Office Action Summary	Application No. 10/614,772	Applicant(s) PLATTS, DAVID A.	
	Examiner William H. Rodriguez	Art Unit 3746

DETAILED ACTION

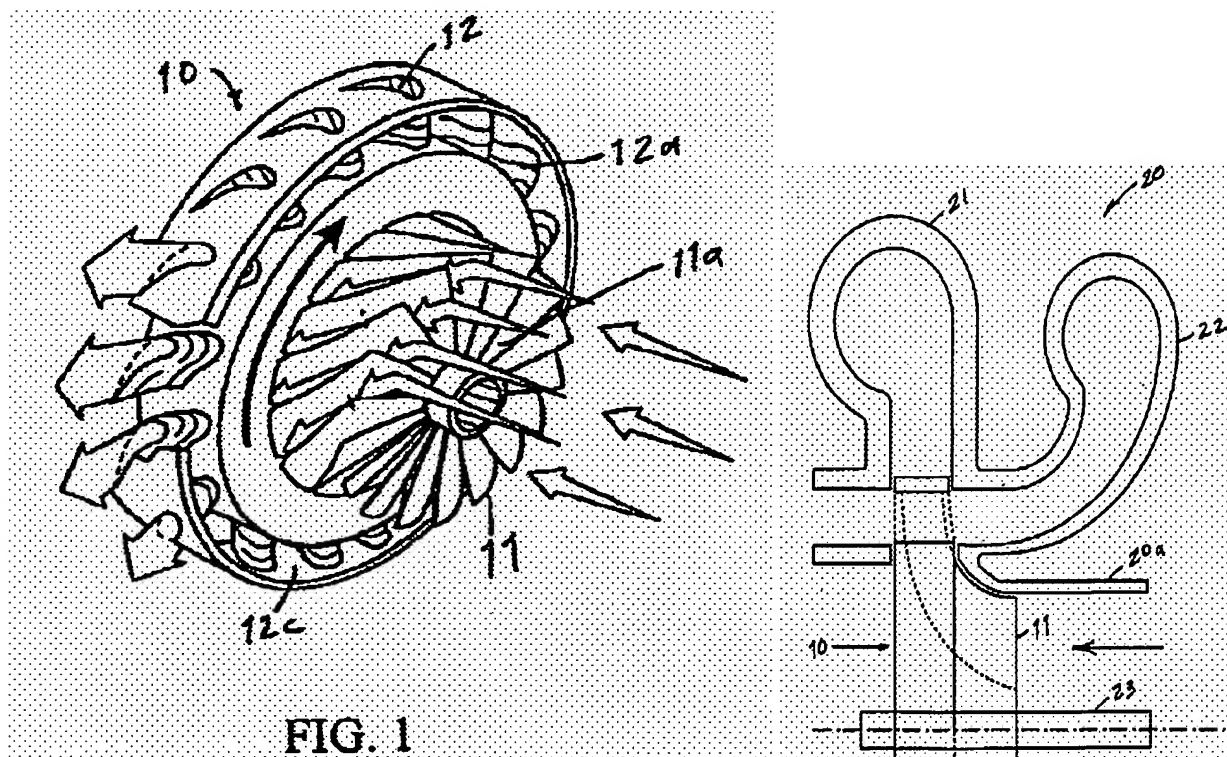
With respect to claim 1, **Platts** teaches a rotor for use in turbine applications comprising: a radial compressor having radially disposed spaced apart fins 64 forming passages, and a radial turbine having hollow turbine blades 60 interleaved with said fins and through which fluid from said radial compressor flows. See particularly **Figures 9 and 10** of **Platts** above.

With respect to claim 2, **Platts** teaches that the rotor further comprises spaced apart turbine fins for receiving said fluid. See particularly **Figures 9 and 10** of **Platts** above.
